Reference H6955/A/16/3154472  
Erection of Free range Egg Production Unit, Access Improvements and  
associated works at  
Caemor  
Llwynmawr  
Pontfadog  
Llangollen  
LL20 7BE

Appeal Reference: H6955/A/16/3154472

## **Landscape and Visual Assessment LETTER REPORT**

Illustrative comparison scale of proposed Poultry Building and likely appearance

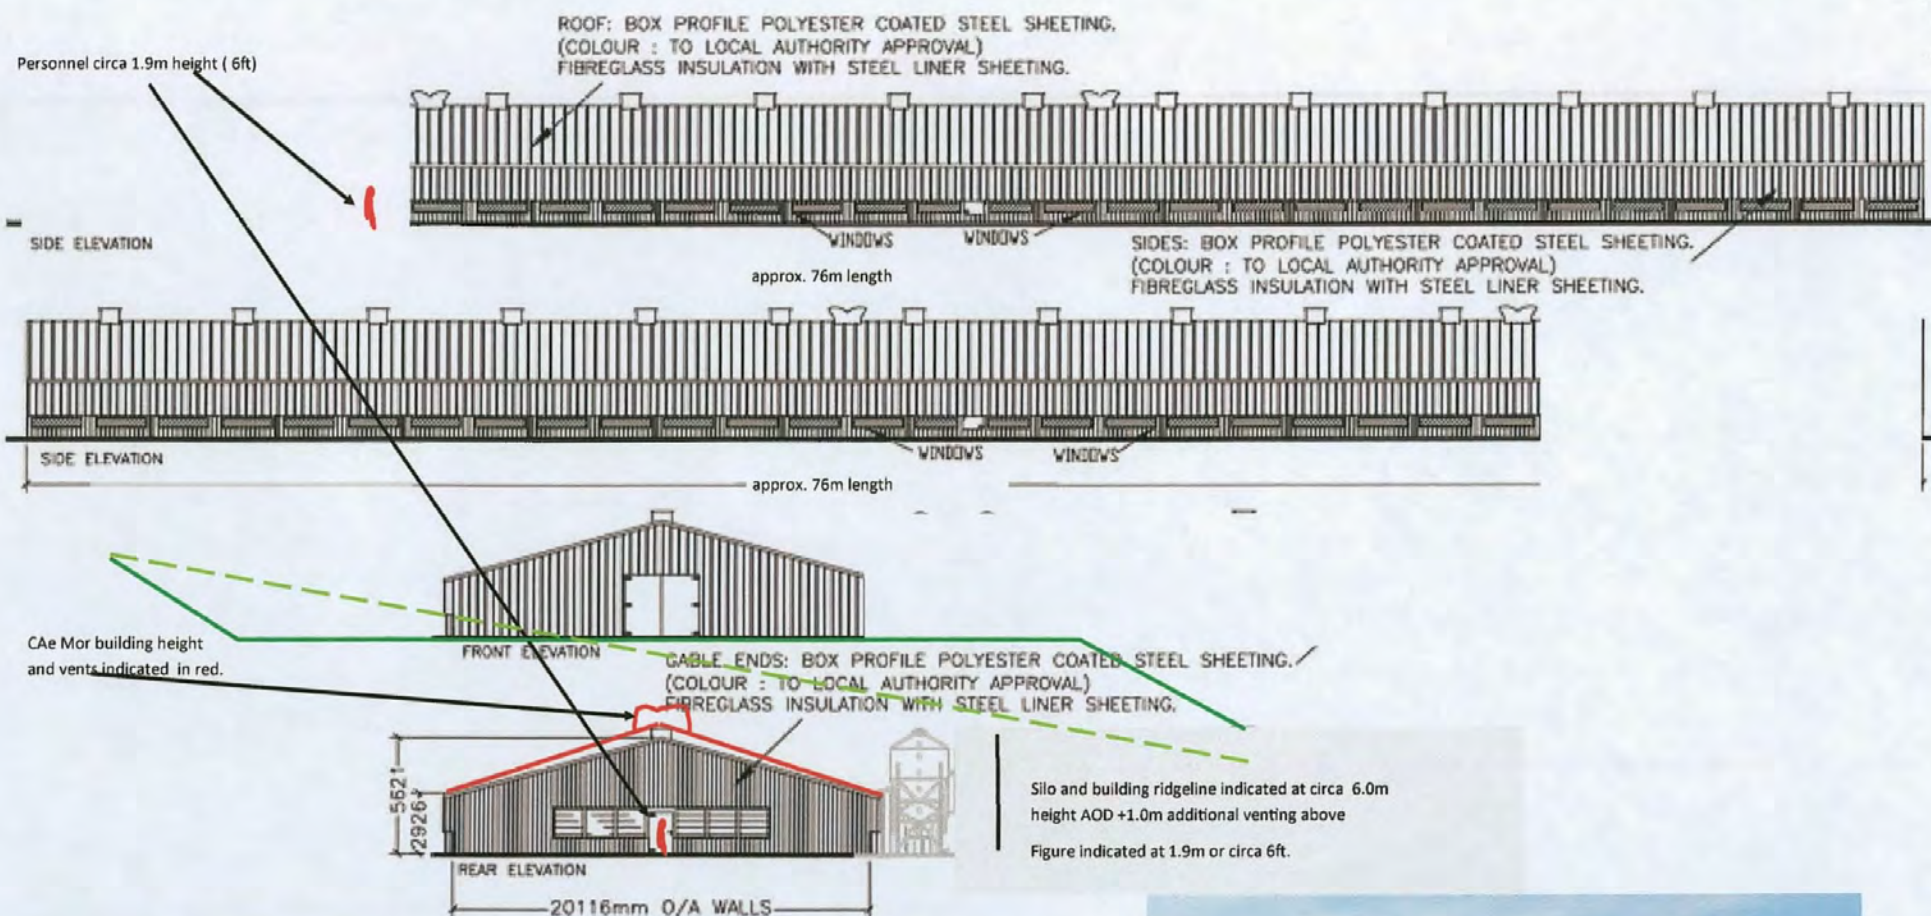
19. Para 40 I would agree that the development has potential to be of medium/high sensitivity with regard to the sensitivity of the Landscape Character Area as described

but with the addition of the changes I consider are not described or taken account of – the sensitivity is increased to high and with particular regard to the proposed access being compliant with modern Highways standards, materials and resultant scale.
